TO:	Andrew Allsopp-Smith, Andrew Fawcett Vineway Limited	Date:	1 July 2025
COPY TO:	Madeleine Wright	Document No:	10122-009-1
FROM:	Mark Delaney

DELMORE FAST TRACK APPLICATION - RESPONSE TO AUCKLAND COUNCIL FRESHWATER ECOLOGY QUERIES

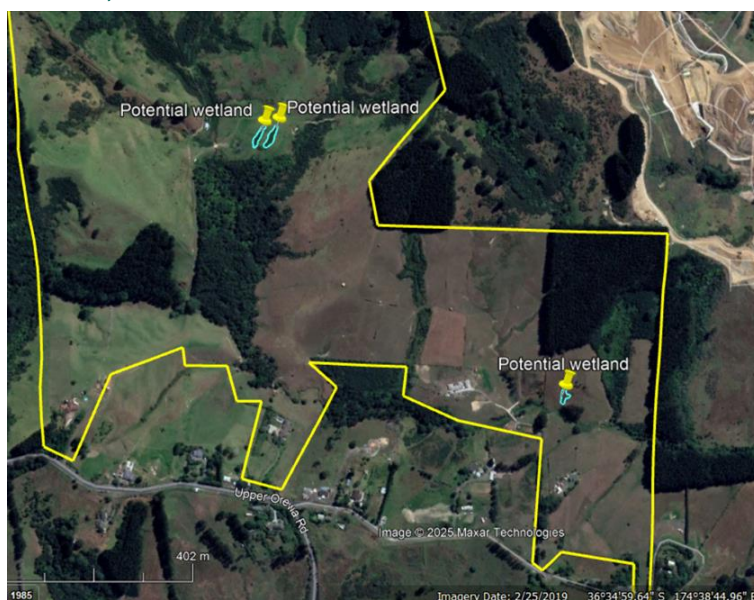
While I am in general agreement with the delineation and classification of wetlands and stream on the study site, I note that an area evidently saturated at the time of our site visit (13/05/2025), was not included in the wetland delineation. This feature is visible on the snip below indicates this area. I consider it likely that this area may meet the definition of natural inland wetland and an assessment as prescribed by the wetland delineation protocols set out by the MfE should be provided to confirm its status.

From Carly Hinde AC Principal Project Lead via email dated 28 May 2025: "please find enclosed the below mapping from Antoinette which indicates several areas where a high water table is visible, as discussed during the meeting. The Viridis assessment has satisfactorily addressed several of them, however, below are three areas that should be revisited."

The two northernmost potential wetland areas are situated on top of a relatively steep hill. Both areas were dominated by kikuyu grass (*Cenchrus clandestinus*) and woolly nightshade (*Solanum mauritianum*), which are classified as facultative upland species (Figure 1). No facultative, facultative wetland, or obligate wetland species were observed, nor were any hydrological indicators present. Accordingly, these areas are not considered natural inland wetlands under NPS-FM.

The southeastern potential wetland is located in an area affected by recent slope instability. A site visit was undertaken on 6 June 2025 to carry out further assessments. In the three weeks preceding the visit, the area experienced significant rainfall, with more than 30 mm falling within a 24-hour period each week. April 2025 also saw several high rainfall events. Notably, over 50 mm of rain fell within 24 hours prior to the site visit, and an additional 2 mm fell on the day itself.

Given these conditions, the assessment was undertaken during abnormally wet conditions, following a prolonged period of elevated rainfall. As a result, the ground across the site was saturated. Due to this excessive surface water and ground saturation, hydrology was not considered a reliable wetland indicator for this site visit, and a formal hydrology assessment was not carried out.

Three vegetation and soil assessments were undertaken within the southeastern potential wetland area in accordance with the wetland delineation protocols (MfE 2022; Fraser 2018; MfE 2021) to assess the presence and extent of any potential natural inland wetland (Figure 2). The vegetation data for the three plots (Plots I, J, and K) are presented in Tables 1–3.

Plots I and J did not meet either the dominance test or the prevalence index test. In contrast, Plot K passed both tests.

Due to the recent slippage and the presence of early colonising species, the area is likely recently disturbed. As such, vegetation alone may not be a reliable indicator of wetland status under current conditions. Therefore, soils were assessed for hydric indicators in each plot.

The soil assessment results align with the vegetation assessments with Plots I and J are not being considered natural inland wetlands, while Plot K meets both vegetation and soil criteria for classification as a natural inland wetland. With the inclusion of Plot K, the total number of wetlands identified within the site is now 35.

Plot K is situated on a flatter area within the stream floodplain, unlike the other two plots. It is likely that hydrology in this location is primarily influenced by stream and groundwater connectivity, rather than surface runoff. Both Plot K and the area around Plot J are located outside of the proposed earthworks footprint (Figure 2).
